Docket Number:	12-AFC-03
Project Title:	Redondo Beach Energy Project
TN #:	206038
Document Title:	Peer review of AES noise analysis with exhibit
Description:	N/A
Filer:	Jon Welner
Organization:	Jeffer Mangels Butler & Mitchell LLP
Submitter Role:	Intervenor Representative
Submission Date:	9/9/2015 6:38:27 PM
Docketed Date:	9/10/2015

Subject: **Redondo Beach Energy Project (12-AFC-03, RBEP)
Review of AES Noise Modeling Data and Ambient Noise Measurements**

FIGURE 1

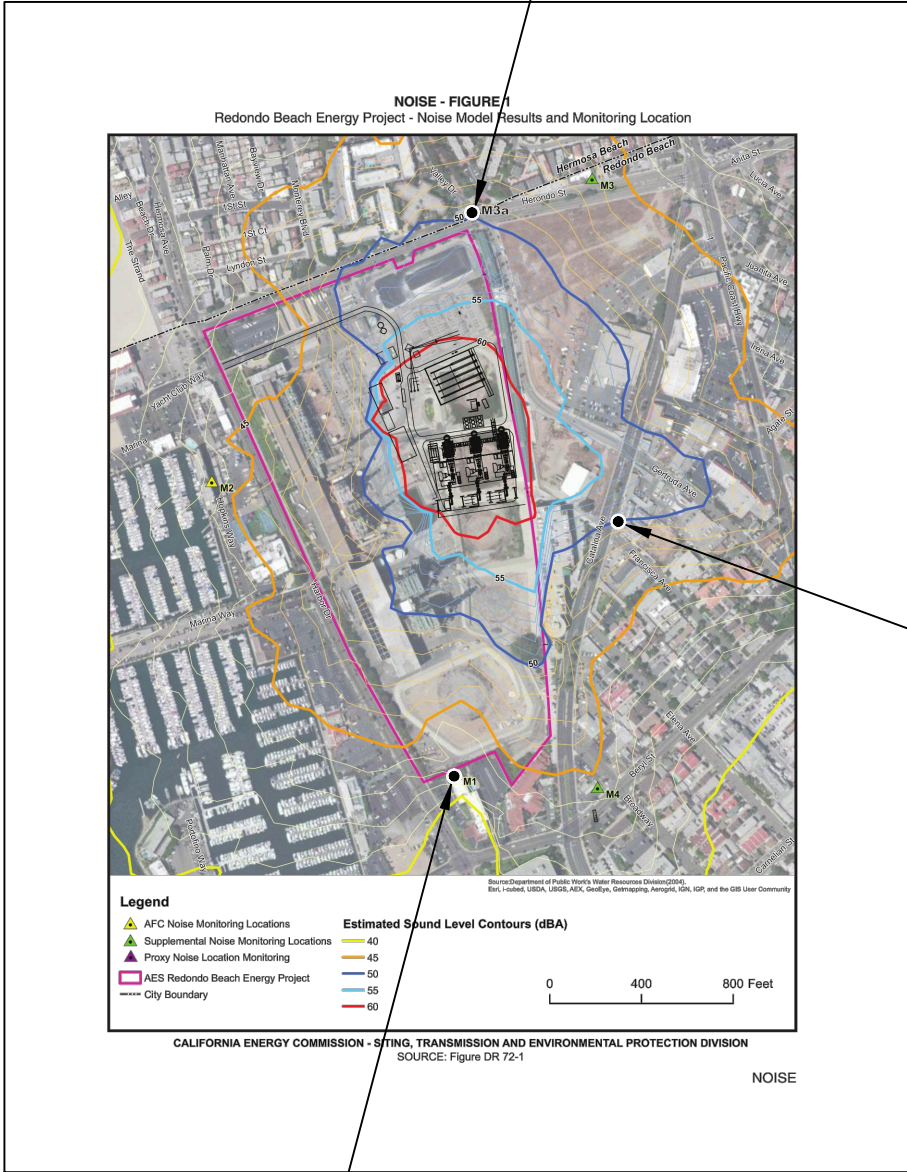
Using the AES sound power levels for the exhaust stack exit and the associated directivity factors, we calculated the expected noise levels at three locations near the project site (as indicated in Figure 1¹). The results of our calculations are summarized in the following table and are compared to the noise contour levels published in the RBEP PSA.

Location	Description	RBEP Published Noise Contour Level (dB)	Exhaust Stack Exit Noise Level Calculated (by Salter, dB)	Difference (dB)
1	Monitor Location M3a, north of the site (nearest residential property in Hermosa Beach)	50	53	+3
2	Nearest Residential Property to the east at the corner of N Catalina Ave. and N Francisca Ave.	50	56	+6
3	Monitor Location M1, south of the site (nearby hotel)	43	50	+7

Using the AES sound power level and directivity factors, we calculated significantly louder noise levels at these locations. In addition, our calculation is for just one source type, the three main exhaust stack exits. There are several other source types that should also be peer reviewed.

¹ In the enclosed Figure 1, our calculated noise levels at three locations are overlaid on the AES-calculated noise contours published in the PSA.

Location 1: 53 dBA
(CSA Calculated)

Location 2: 56 dBA
(CSA Calculated)

Location 3: 50 dBA
(CSA Calculated)
